STATE OF MAINE
 DEPARTMENT OF TRANSPORTATION
 16 STATE HOUSE STATION
 AUGUSTA, MAINE 04333-0016

April 25, 2016
 Subject: Bridge Rehabilitation
 State WIN: 017880.00
 Location: **Oxbow PLT**
Amendment No. 1

STATE OF MAINE		DEPARTMENT OF TRANSPORTATION		BH-1788(000)X		WIN		BRIDGE NO. 2877		17880.00		BRIDGE PLANS	
UMCOLCUS STREAM BRIDGE		UMCOLCUS STREAM		AROOSTOOK COUNTY		ESTIMATED QUANTITIES		GENERAL CONSTRUCTION NOTES		SHEET NUMBER		2A	
OXBOW PLT		AROOSTOOK COUNTY		ESTIMATED QUANTITIES		GENERAL CONSTRUCTION NOTES		SHEET NUMBER		2A		OF 18

SUPERSTRUCTURE PLAN
 STAGE 2 (UPSTREAM SIDE)

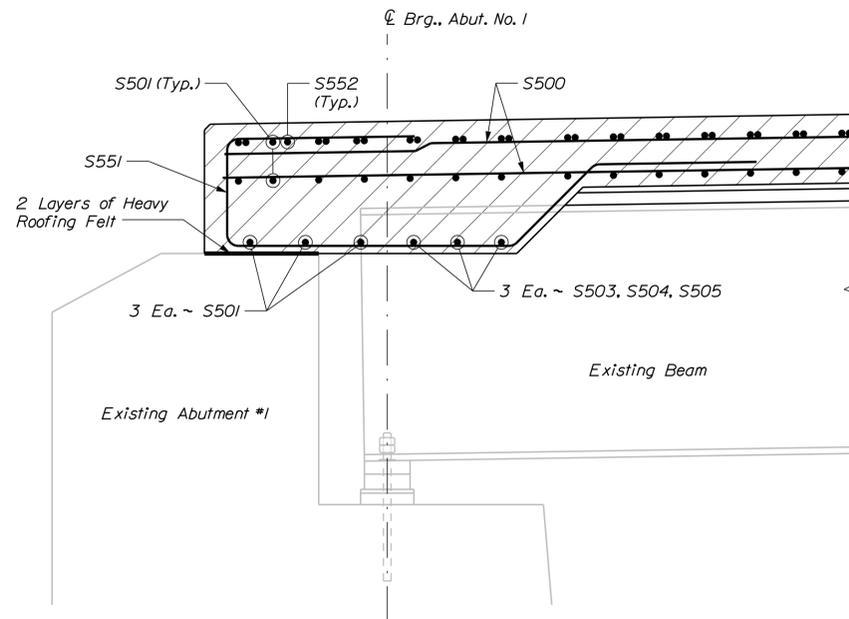
Question: Can a mechanical splice with a lap splice + a full length bar be substituted for bar mark S501 as noted.

SET "A"
 1 ~ S501 & 1 ~ S552 (Top)
 1 ~ S501 (Bottom)
 2 ~ Mechanical Welded Splice

NOTE:
 Rebar With Mechanical Welded Splices
 Will Have To Be Field Cut To Length.

Response: Yes, a welded/mechanical splice with a lap splice and a full length bar can be substituted for bar mark S501. The additional reinforcing steel required for the lap splice will not be measured for payment or paid for.

SHEET NUMBER
17A
 OF 18

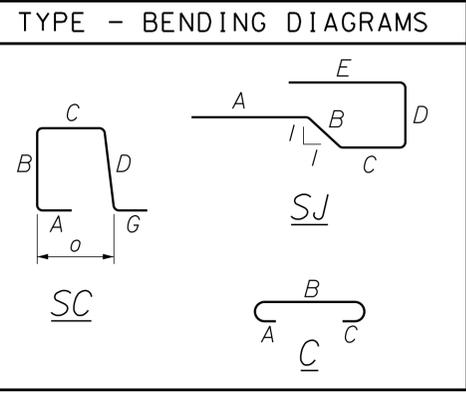
Question: can you verify the piece count for Bar Mark S551.

PROJ. MANAGER	M. WIGHT	BY	DATE
DESIGN-DETAILED	R. Bulger	M. Poulin	8/2013
CHECKED-REVIEWED	T. Helm	W. Rainman	4/2016
DESIGN-DETAILED			
REVISIONS 1	By S551 Quantity of 22 to 44 Total		4/21/16
REVISIONS 2	By S552 Change to S552		
REVISIONS 3			
FIELD CHANGES

Response: For Bar Mark S551, the correct count is 44. Please refer to sheet 17A for the updated reinforcing steel schedule.
